# Access Compliance Report

## Public Rights-of-Way

Intersection ID: 23633	Main Street: HILLSIDE_LN	Cross Street: LARRISA_CT	Location: NW
ADA ID: 61A8C9043692	Ramp Type: PerpDiag	Initial Pass/Fail: Fail	Overall Compliance: No
		Severity Score: 10

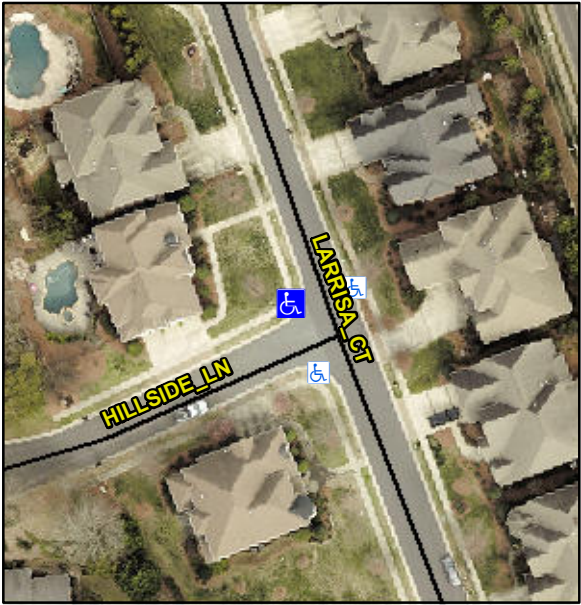
Codes/Mitigation Info/Possible Solution			Field Measurements/Component Compliance		
	Possible Solutions:		<b>Compliance</b>	<b>Description</b>	<b>Data</b>
	<b>Remove &amp; Replace Curb Ramp With Two New Directional Ramps or Equivalent.</b>		<b>Yes</b>	Ramp Length (in)	96.0
			<b>No</b>	Ramp Width (in)	37.0
			<b>N/A</b>	Flare Type LT	N/A
			<b>N/A</b>	Flare Slope LT (%)	N/A
			<b>N/A</b>	Flare Traversable LT?	N/A
			<b>N/A</b>	Landing Length (in)	N/A
			<b>N/A</b>	Landing Width (in)	N/A
			<b>N/A</b>	Landing Slope (%)	N/A
			<b>N/A</b>	Landing X Slope (%)	N/A
<p>Surveyor Notes:</p> <p><b>N/A</b></p>			<b>N/A</b>	Landing Curb? (Y/N)	N/A
			<b>N/A</b>	Shared Landing?	N/A
			<b>N/A</b>	Gutter Ponding?	N/A
			<b>N/A</b>	Gutter Lip Ht (in)	N/A
			<b>No</b>	Painted X Walk1?	N/A
			<b>To S</b>	X Walk 1 Direction	N/A
			<b>N/A</b>	X Walk 1 Width (in)	N/A
			<b>3.5</b>	X Walk 1 Slope (%)	N/A
			<b>2.2</b>	X Walk 1 X Slope (%)	N/A

<b>N/A</b>	Ramp inside XWalk1?	N/A
<p>PROW/ADA:</p> <p><b>Not Found, R304.5.1, R304.5.3</b></p>			<b>1.4</b>	Road Slope (%)	N/A
			<b>3.0</b>	Road X Slope (%)	N/A
			<b>N/A</b>	Any Obstructions?	N/A
				Obstruction Type	N/A
			<b>N/A</b>		N/A
			<b>Yes</b>	Surface Condition? (G/P)	Good
Total Cost:		\$ 3200.00
